P. 39332
A. REPAIR

SEWAGE DISPOSAL SYSTEM
MARYLAND STATE DEPARTMENT OF HEALTH DISTRICT 4

HOWARD COUNTY
BUREAU OF ENVIRONMENTAL HEALTH
461-9933

PLOT PLAN
LANDS CONVEYED TO
CHRISTOPHER H. MILES
AND
CATHERINE B. MILES
LIBER 1674 FOLIO 269
SITUATED ON SOUTHWEST SIDE OF
MD. RTE. # 144 ~ FREDERICK ROAD
FOURTH ELECTION DISTRICT
HOWARD COUNTY, MARYLAND

P
39332

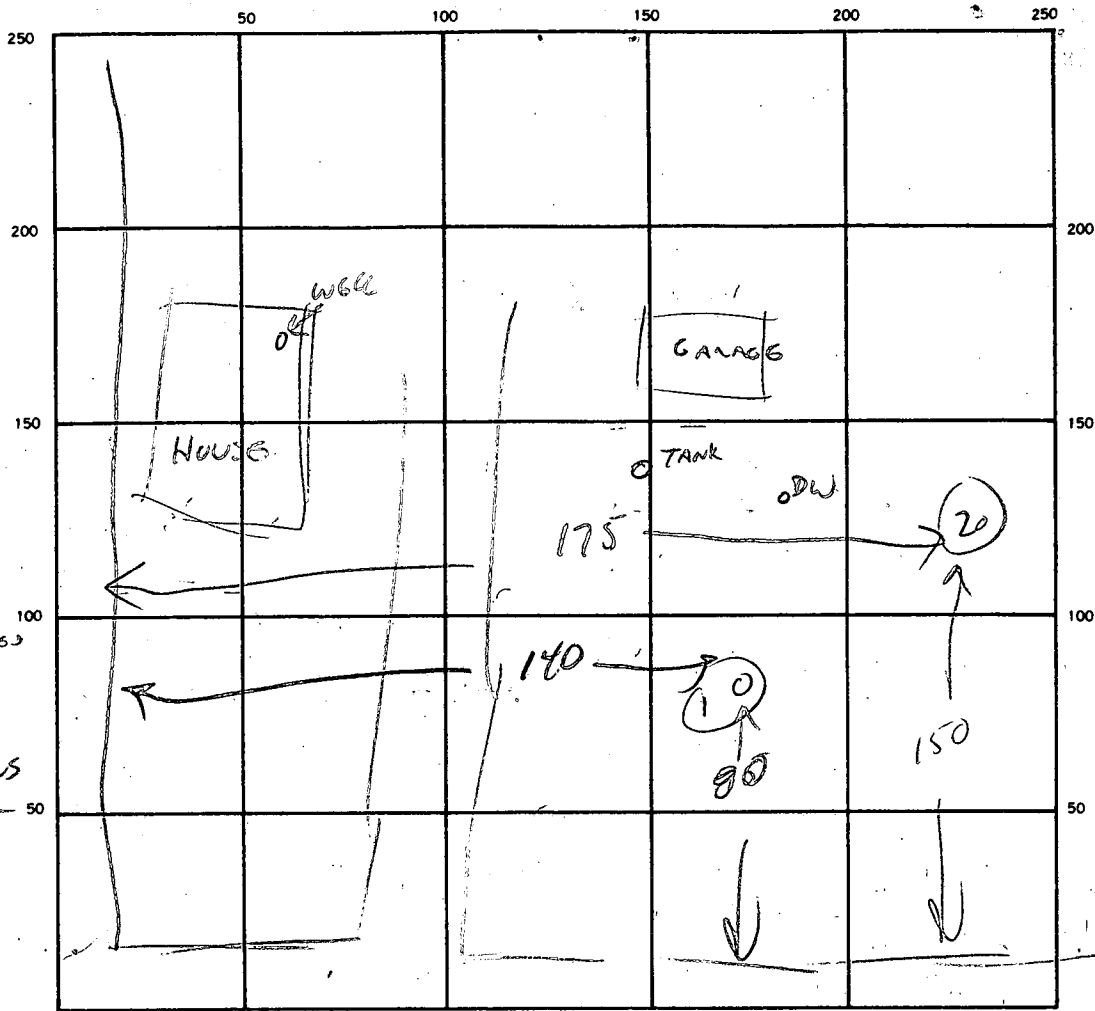
SMI
 HOLE 1
 DID NOT COMPLETE TEST - MOVING SLOWLY
 ESTIMATE 30-40 MIN PENETRATION AT 3'

HOLE 2
 3' 11/15 11/48 12/02
 4 MIN AT 3'
 BOTH HOLES HEAVILY FRACTURED BUT NOT CONTINUOUS VEINS
 5-9' UNTIL REFUSAL
 6/2/82

REMARKS EXISTING DW HAS < 1' EFFLUENT IN BOTTOM.
20 YEARS OLD INSTALLED IN FRACTURED ROCK AS EVIDENCED
BY REPAIR HOLES.
LEVEL OF TREATMENT BELIEVED REASONABLE CONSIDERING
AMOUNT OF TIGHT SOIL AROUND ROCK.
OR TO BUILD REPLACEMENT 3 BR HOME USING EXISTING SYSTEM (INLET TO TANK
IS 4' BELOW GRADE)
HOUSE HAS BEEN HEAVILY TREATED FOR TERMITES. WELL CONTAMINATION POSSIBLE.

EH - 2-1186

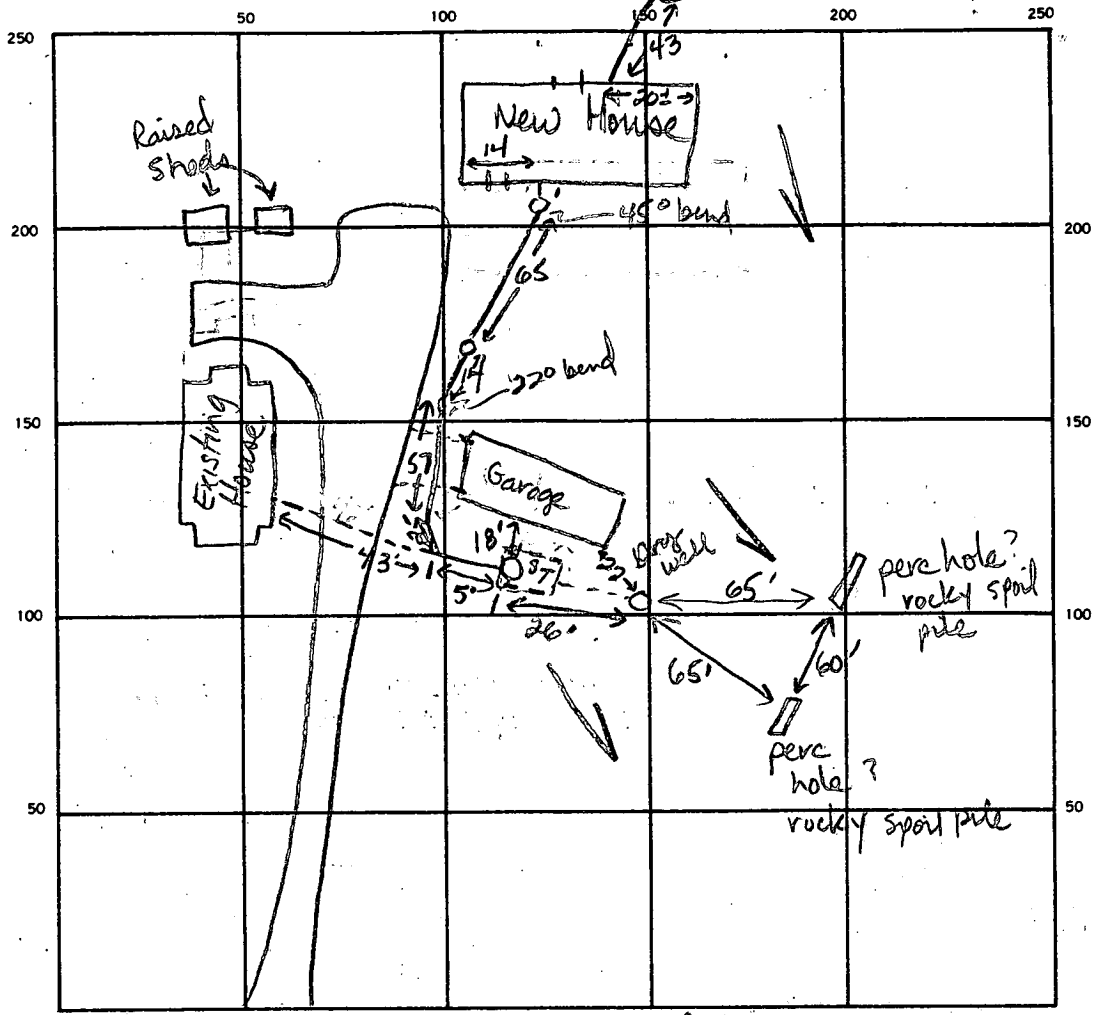
REMARKS 4-6-88 Septic line from new house to existing tank is ok to cover. Old septic line is under driveway to old house. Existing drive to old garage goes over the septic line from the new house. Could not locate old well. Ok to cover all work JEN

IMPROVEMENT LOCATION SURVEY
 MILES PROPERTY
 LIBER 167d Foud 269
 HOWARD COUNTY, MD.

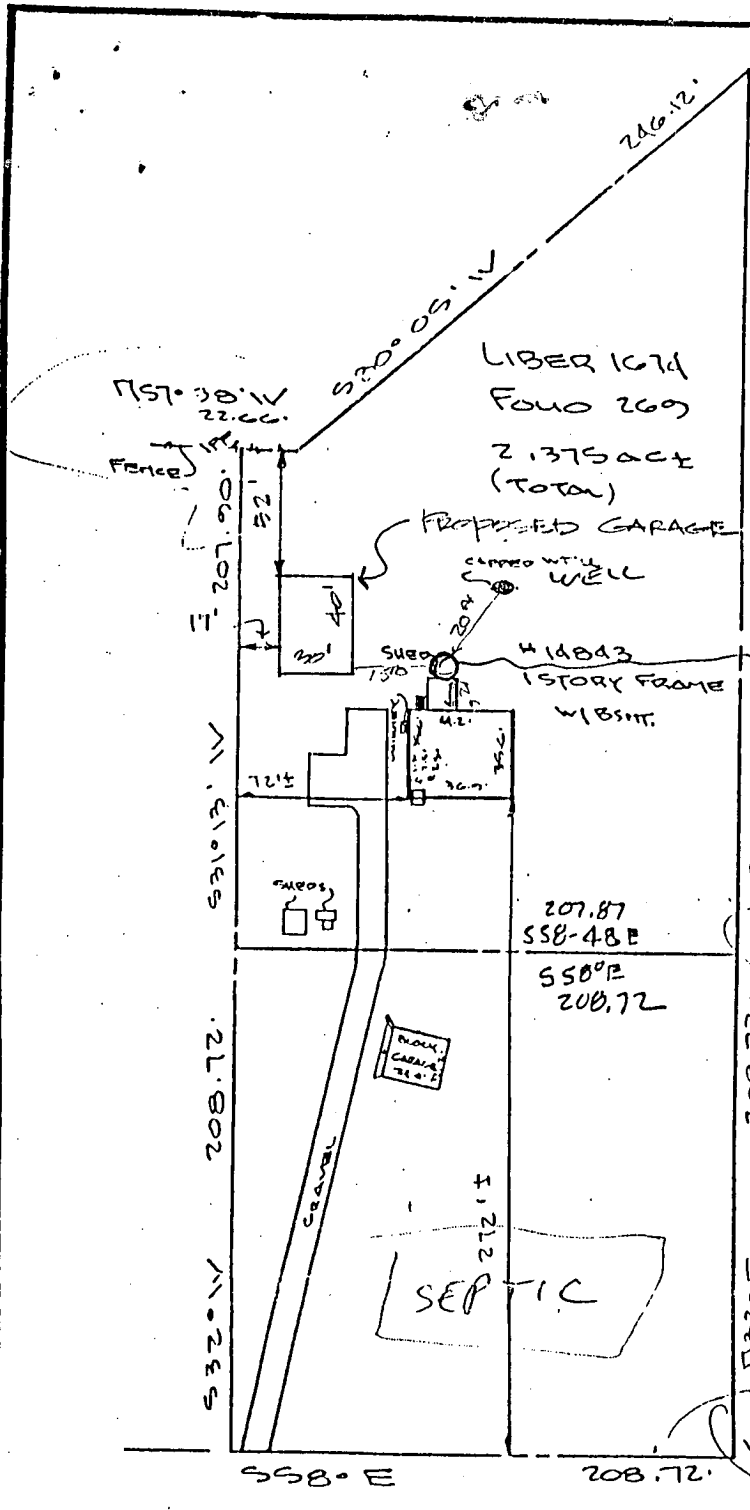
SHED HAS
 NO IMPACT
 OK TO SIGN
 MR 5/13/94

IMPROVEMENT LOCATION SURVEY
 MILES PROPERTY
 LIBER 1674 FOLIO 269
 HOWARD COUNTY, MD.

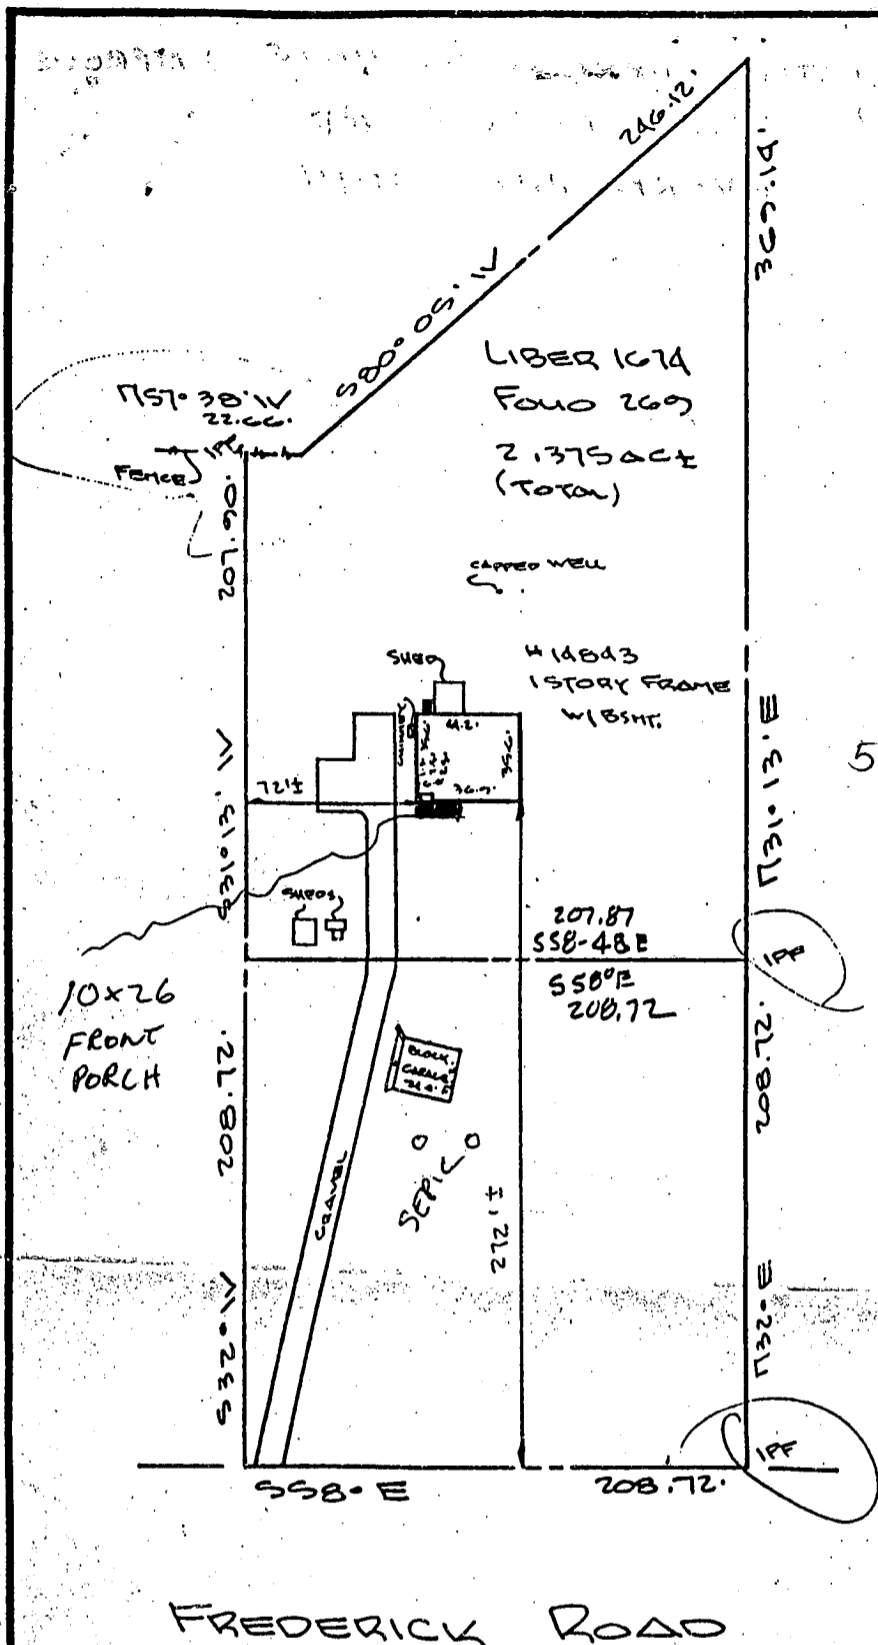
5-23-96
 Proposed pool location <30' from well - no ~~other~~ adjustment possible - OK to proceed as shown - well is uphill from pool thus seepage from pool will not adversely affect well potability

5/7/97
 Proposed porch location as shown (DKS)
